WATERFORD 3 BASEMAT EVALUATION
STRUCTURAL & GEOTECHNICAL ENGINEERING BRANCH
DIVISION OF ENGINEERING

Geotechnical Engineering Evaluation of Concrete Cracking in the Basemat Waterford No. 3

Structural Engineering Evaluation
of Concrete Cracking in the Basemat
Waterford Unit No. 3
John Ma, Structural Engineer

ENCLOSURE 1

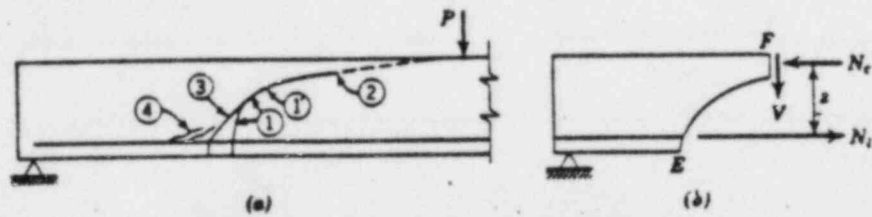
J. Ma's Question on 4/4/84

Provide shear capacity and design shear stress in the mat in two regions:

- A. Bounded by column line 12M and 7FH in N-S direction and T2 and R in E-W direction. This shear stress and shear capacity is measured along the 45° line from R column line toward column 12M.
- B. Bounded by column line 12M and 7FH in N-S direction and column line R and P. This shear capacity and stress should be E-W direction.

- A. The design shear stress under normal operation condition (Load Factor = 1.0) along the 45° line as defined is 64 K/ft. The ultimate shear capacity of the mat is 274 K/ft which includes 98 K/ft. from shear reinforcement (#11 @ 3'-0 center each way), and 176 K/ft. from concrete. The allowable concrete unit shear stress is calculated based on $2\phi\sqrt{f_c'}$, where $\phi = 0.85$ and f_c' are 4,000 psi.

The design shear stress under DBE loading combination is 166 K/ft.

- B. The design shear stress under normal operation condition is 52 K/ft, and the ultimate shear capacity same as "A", 274 K/ft.

The design shear stress under DBE loading combination is 210 K/ft.
